# SPARTAN CHASSIS, INC.

CSB03-280-002

## CAMPAIGN SERVICE BULLETIN

**SUBJECT:** Cab Tilt Bracket Rework

**FIG. 2-1**

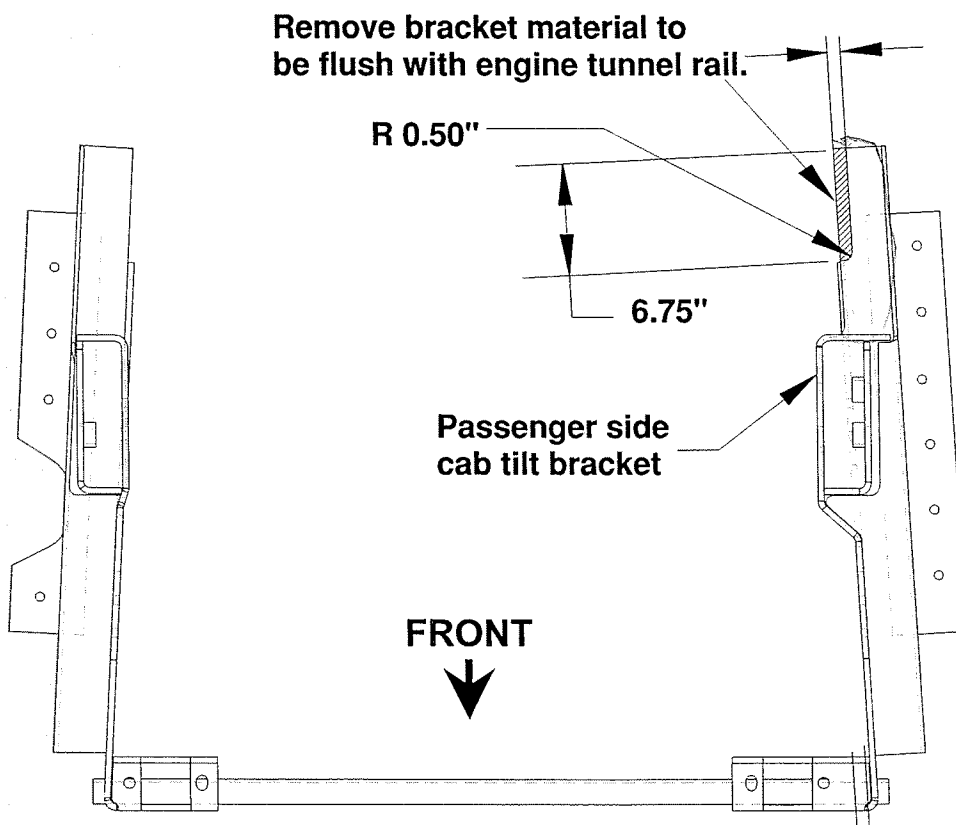
**CONDITION:** Possible Interference Condition

3. Refer to FIG. 2-1. Locate the cab tilt bracket on the passenger side of the engine tunnel rail. Measure from the most rearward edge of the bracket forward 6.75" and mark.
4. Using a sawsall, cut away section of bracket as shown in FIG. 2-1, aligning the sawsall blade flush with the tunnel rail.

**Note:** To avoid damage to the insulating foam along the engine tunnel, use an angle cut along the tunnel rail.
